Proposed 7 borings -
convert 2 to MWS

March 18, 1994
SCI 820.002

Work Plan
Soil and Groundwater Contamination
Characterization Investigation
MIBK Underground Tank Release
6707 Bay Street
Emeryville, California

SITE PLAN			PLATE 1
6707 BAY STREET - EMERYVILLE, CA			
JOB NUMBER 820.001	DATE 4/12/93	APPROVED <i>llx</i>

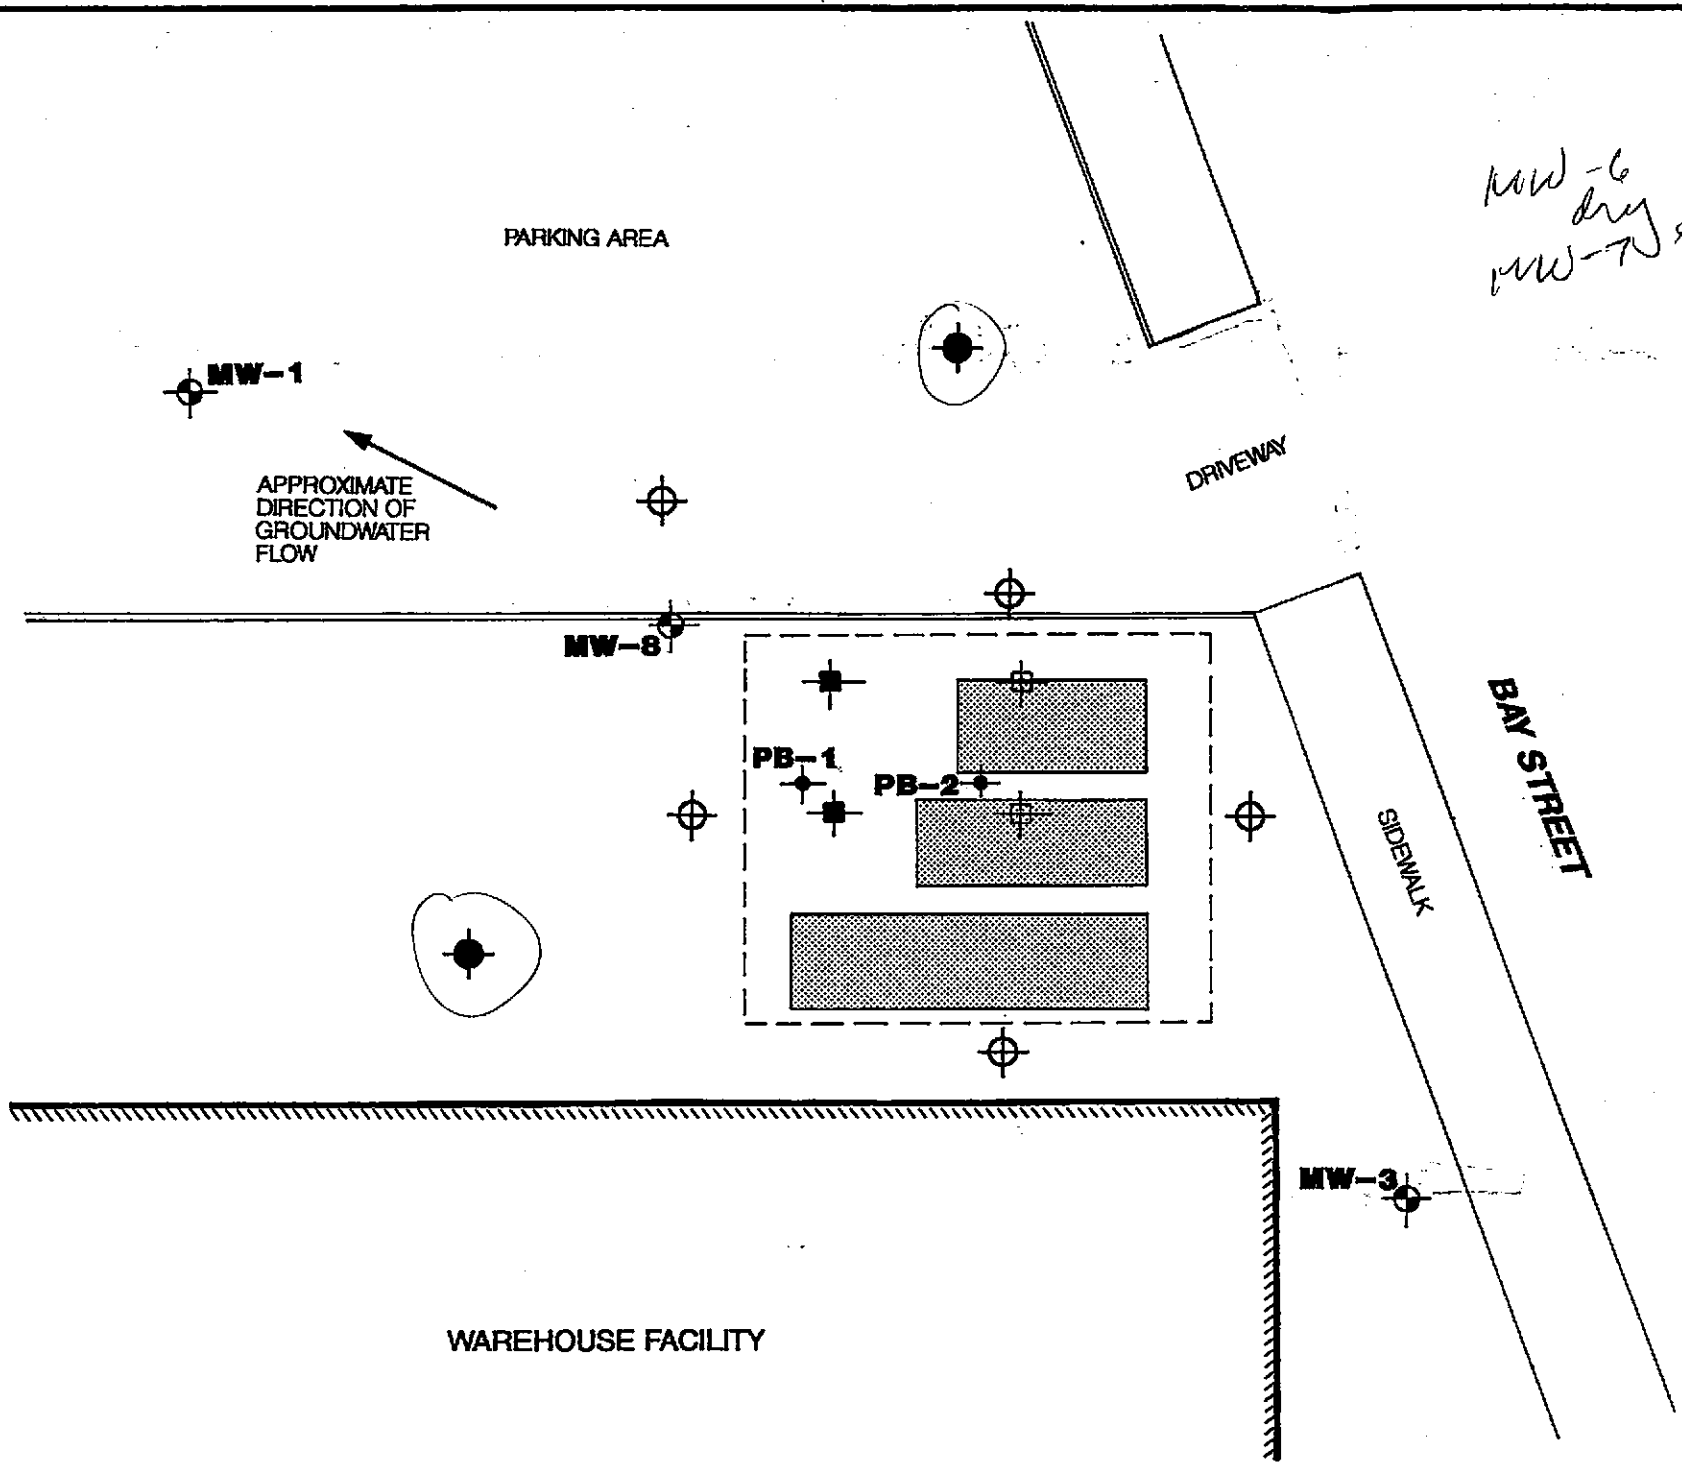
- 1) wells referenced to msk
- 2) soil samples analyzed for
MEK, MIBK, TOG, BTEX TPH
TPH diesel
- 3) submit MW construction
diagram
- 4) pipings - still on site
- 5) need deposit

*MW-6 dry
MW-7 extraction*
